PROJECT: **City of Sterling Heights – Dodge Park Improvements**
Sterling Heights, MI

DMA PROJECT NO: **16078A**

ADDENDUM NO: **3**

ISSUE DATE: **July 7, 2017**

job no. 16078A sheet no. M5.1

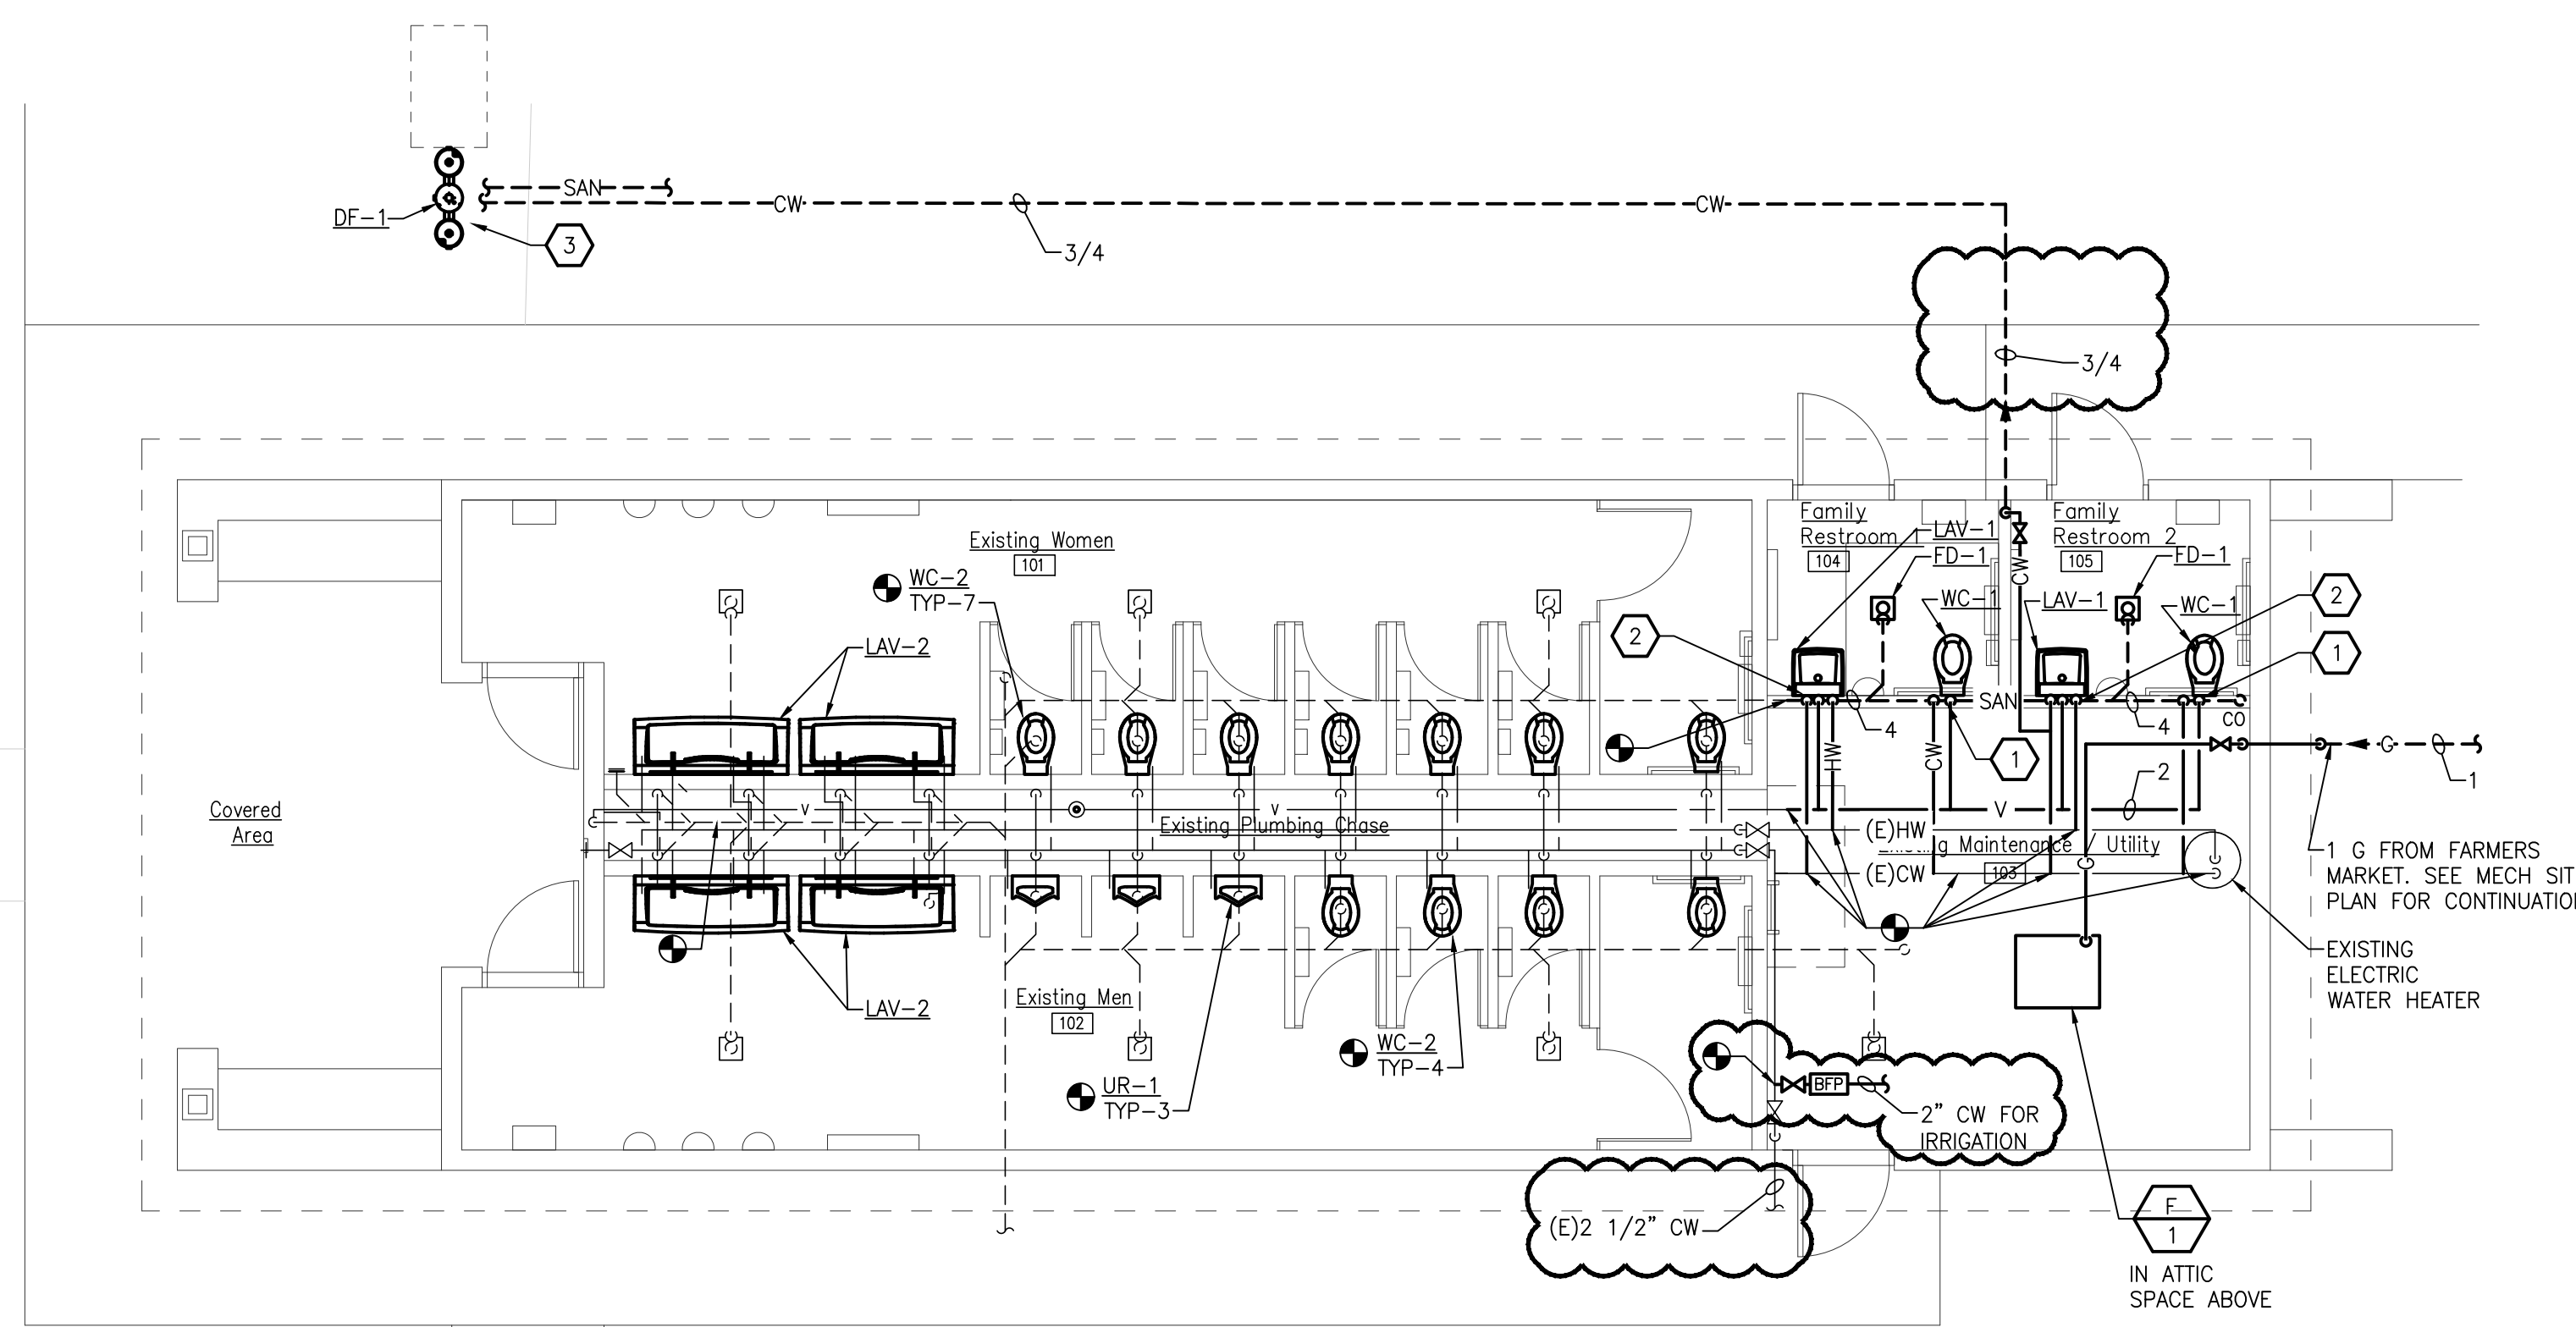
1. Revised sheet M5.1 for the following: clarified pipe sizes on plan as shown, added CW connection for irrigation system, replaced Mechanical General Notes with Plumbing General Notes, and revised Keyed Notes.
2. Revised sheet E0.1 for the following: Added circuit numbers for the site work and clarified scope of alternate work.
3. Revised sheet E4.1 for the following: Added location of electrical panel.
